STATE OF MAINE
DEPARTMENT OF TRANSPORTATION
16 STATE HOUSE STATION
AUGUSTA, MAINE
04333-0016

December 28, 2006
Subject: **Topsham**
Pin No. 14062.11
Amendment No. 2

Work under this contract is generally described as the construction of the MaineDOT TOPSHAM HIGHWAY MAINTENANCE GARAGE

VIEW F-F
1/8" = 1'-0"

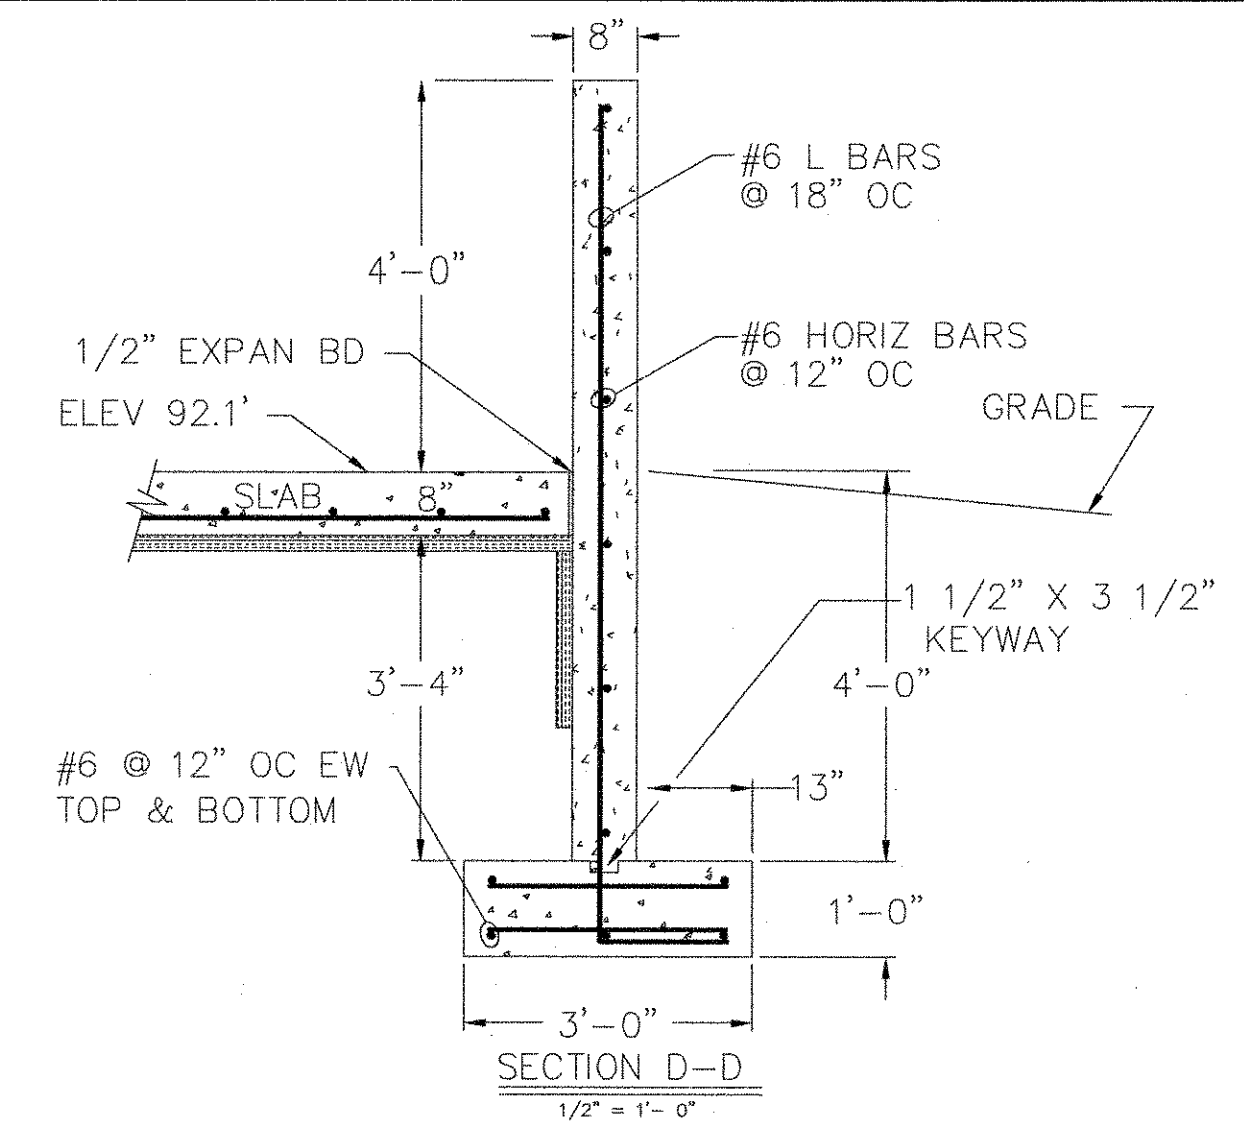
Question: Drawing S-2. Is the top of slab elevation 108.0 or 92.1?

Response: Drawing S-2 has been removed and replaced by the attached plansheet S-2A, the elevation is 92.1

DATE 05-19-06	SCALE AS SHOWN	JOB NO LP ENG 300-01-06	DRAWING NO S-1
BY L P Pelletier	CHKD CHKD

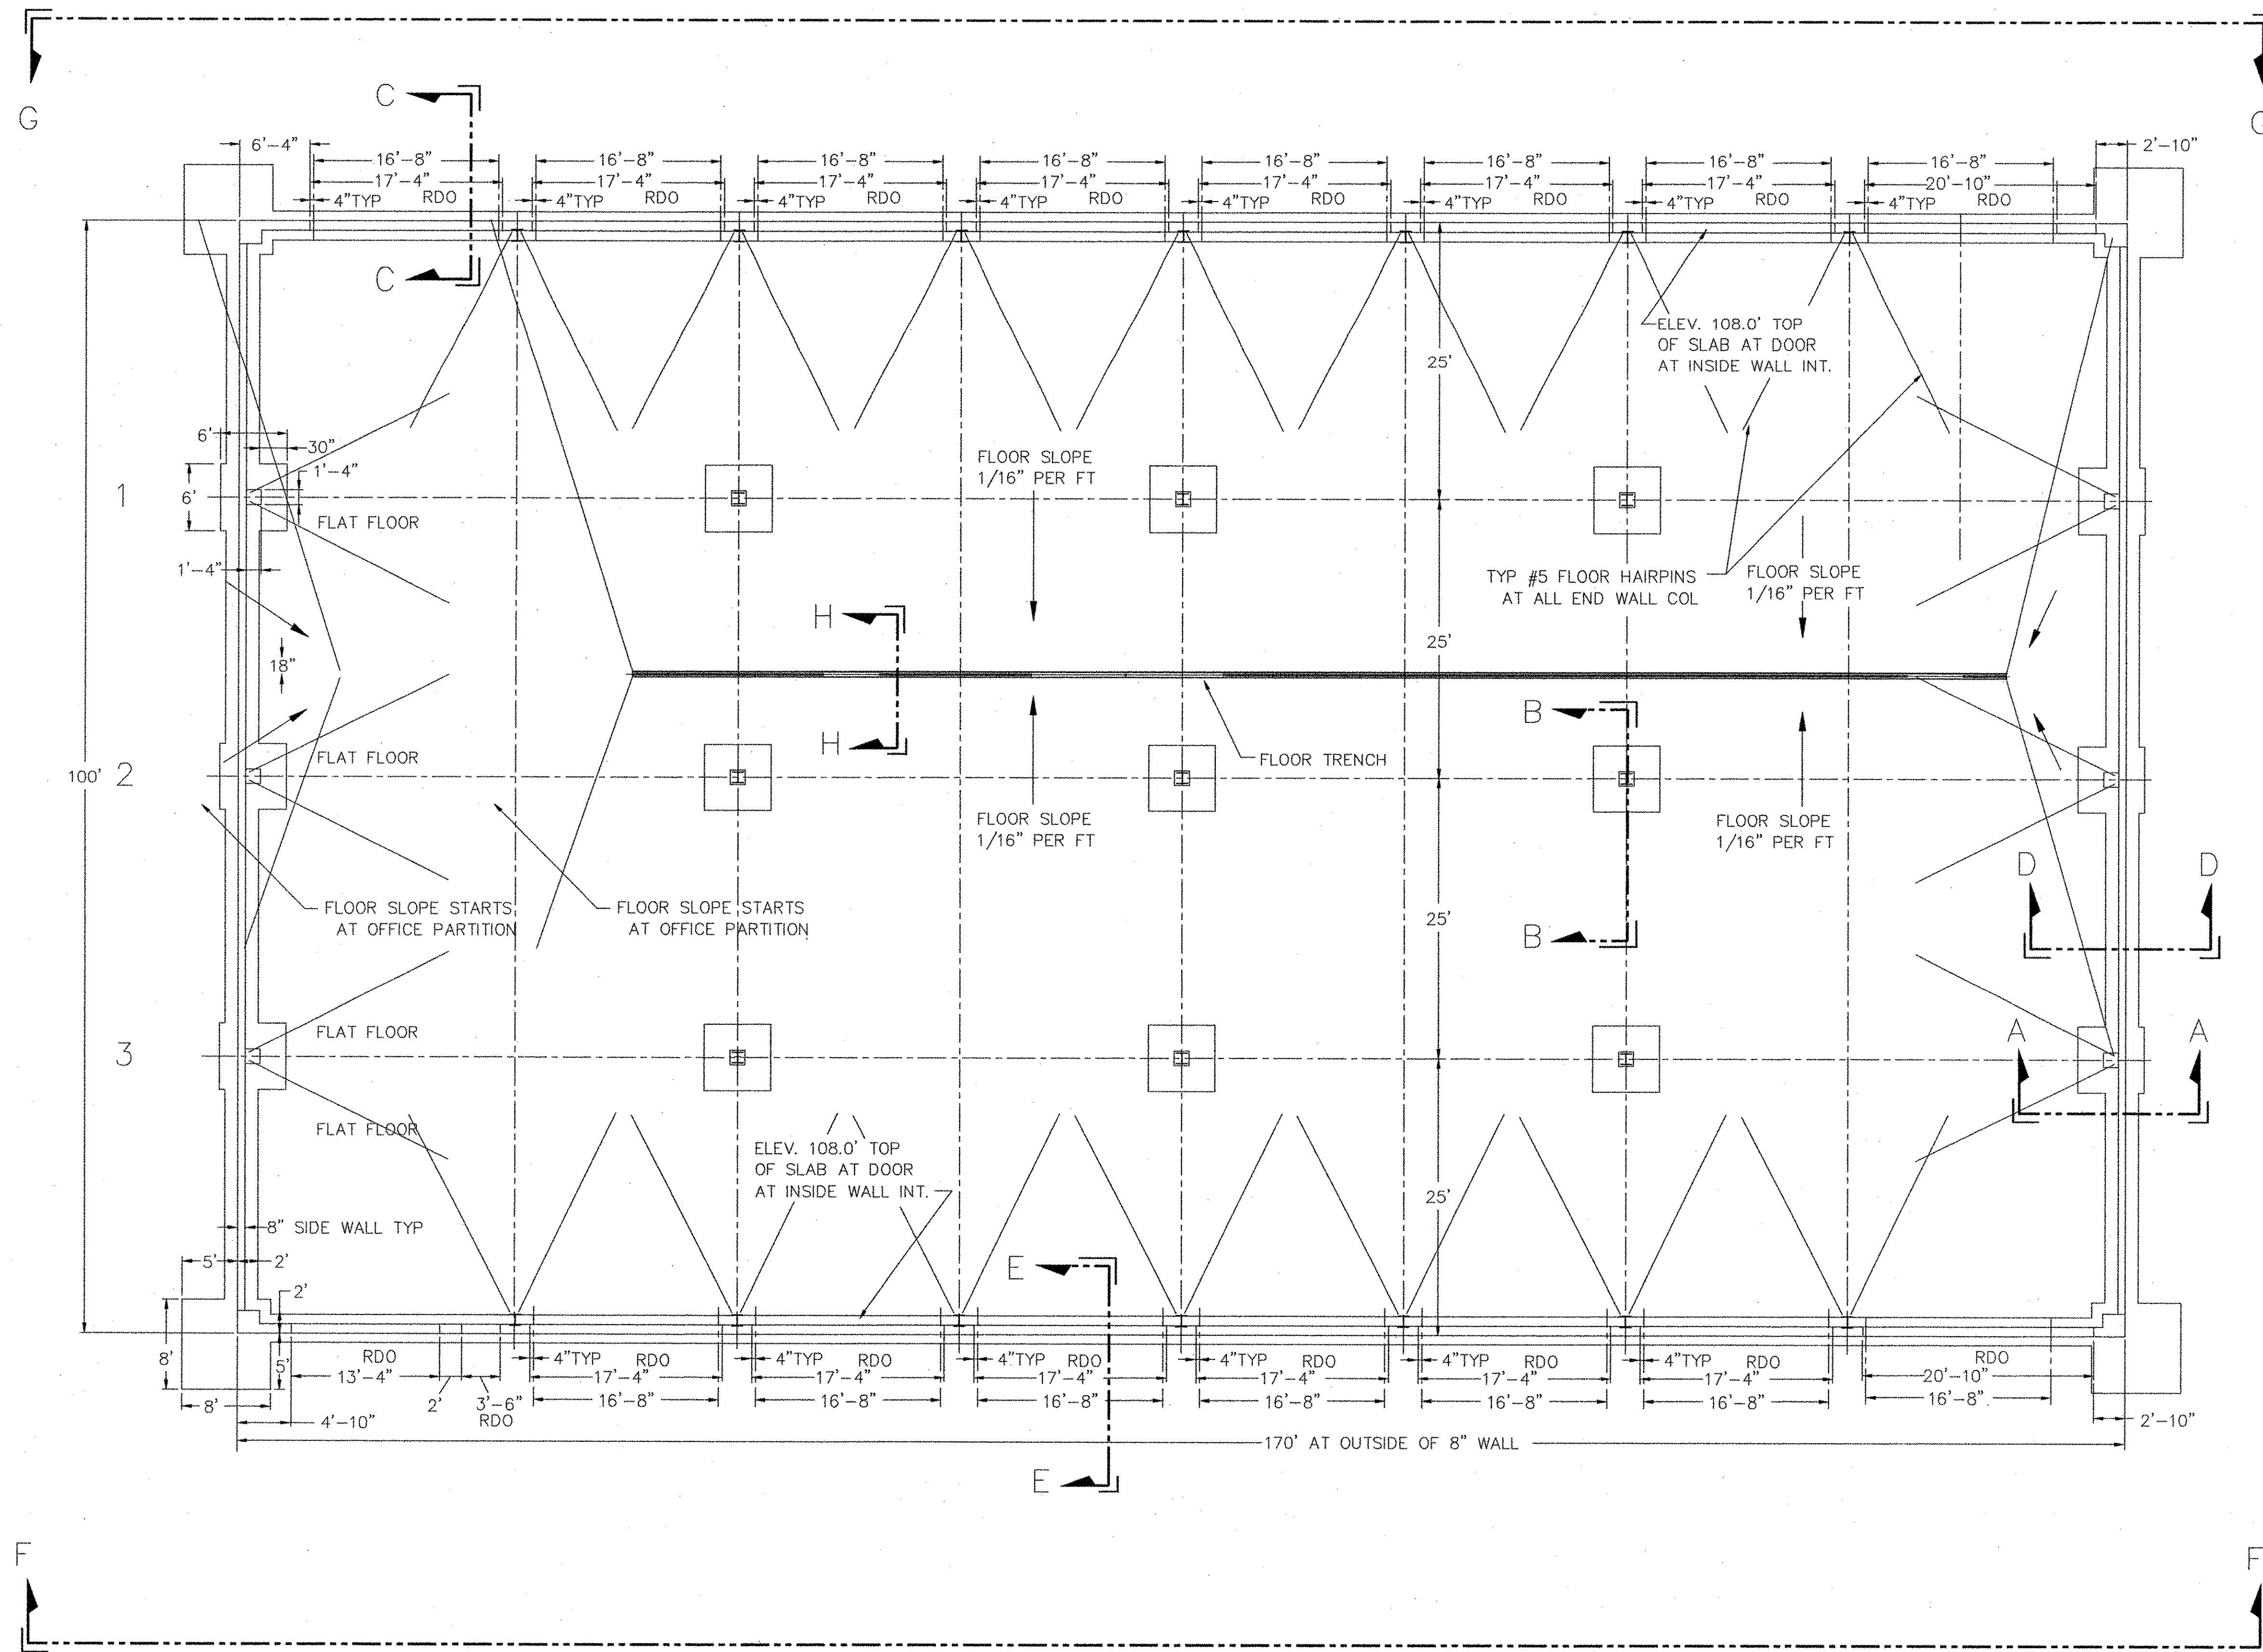
On plan sheet "S-1, Building Foundation Plan" under "Notes" DELETE in its entirety Note 2 that begins "Sand or Crushed Stone..." and REPLACE with the new updated Note 2 that reads: "Granular borrow meeting the requirement of MDOT Standard Specification 703.18 Granular Borrow or crushed stone is to be used for backfill around footings and walls." Make this change in pen and ink.

On plan sheet "S-1, Building Foundation Plan" DELETE in its entirety Note 3 that begins "All subsurface material..." and REPLACE with the new updated note that reads "All subsurface material added under floor is to meet the requirement of MDOT Standard Specification 703.18 Granular Borrow or crushed stone placed in 6" maximum lifts and compacted to a 95% compaction before adding next lift." Make this change in pen and ink.

Question: Drawing S-1. There appears to be interior column footings missing on two lines. Is this correct?

Response: Drawing S-1 shows the proper amount of interior columns.
